SEABROOK STATION
Engineering Office:
1671 Worcester Road
Framingham, Massachusetts 01701
(617) - 872 - 8100

January 26, 1983 SBN-435 T.F. 02.2.2

Interim 10CFR50.55(e) Report; Solid State Protection System Power Surge

NS-EPR-2638

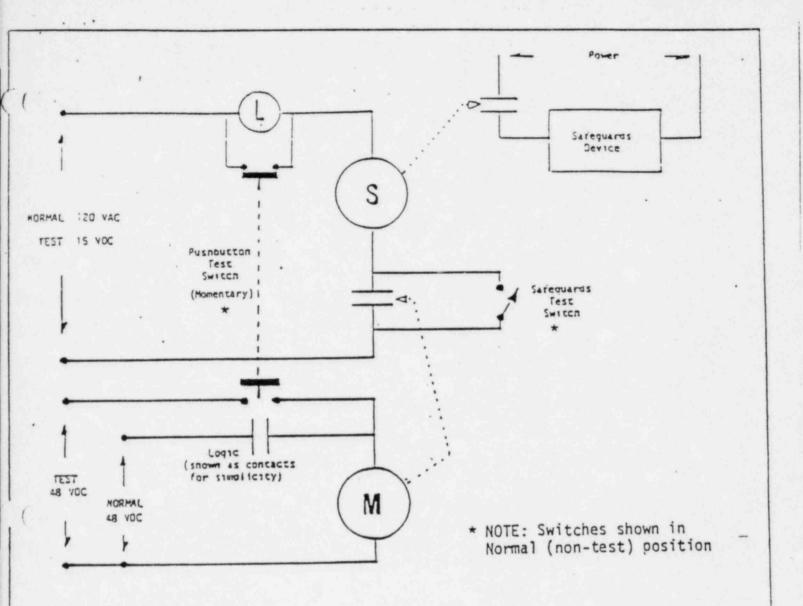
As mentioned above, output relay coil continuity is confirmed at the SSPS, without operating the relay, by reducing the circuit voltage to 15VDC from 120VAC. As shown in the sketch, operation of the master relay by means of the pushbutton test switch also removes the shunt from the SSPS proving lamp and allows the 15VDC to energize it to confirm the continuity of the output relay coil.

Upon completion of the master relay and output relay coil continuity tests, 120VAC circuit voltage is restored. However, if the switch contacts which shunt the proving lamp should fail to reclose as expected, 120VAC would be applied to the lamp in event the system were called upon to operate. Depending on the output relay coil impedance and the number

of output relays being operated by the master relay contacts, the current through the lamp could cause it to burn open before the output relay(s) energized. In such an instance associated Safeguards devices in the affected train would not actuate. Since, during circuit analysis, all identified nondetectable failures must be assumed to have occurred, the redundant Safeguards actuation train must be assumed to be similarly, if not identically, failed.

If contacts shunting proving lamp L do not reclose when pushbutton PROSLEM: is released and system is return to Normal, then 120 YAC would be applied to Slave relay coil thru the proving lamp if Sarequards actuation were called for by the Logic "contacts".

Although failure of the subject test switch contacts is highly improbable, Westinghouse is recommending a minor revision to test procedures conducted from the Safeguards Test Cabinets where operation of the SSPS output relays is verified. The revision will ensure that the relay test circuits in the SSPS operated properly when the system was returned to its normal operating mode. The procedure changes are described in Attachment III and are recommended until Westinghouse completes a review of its consideration of design changes.

Perform the test described below immediately following completion of the Solid State Protection System (SSPS) Output Relay Testing.

This test will ensure that the pushbutton or relay contacts used to shunt the output relay continuity lamps located on the Output Relay Test Panel have returned to the closed position.
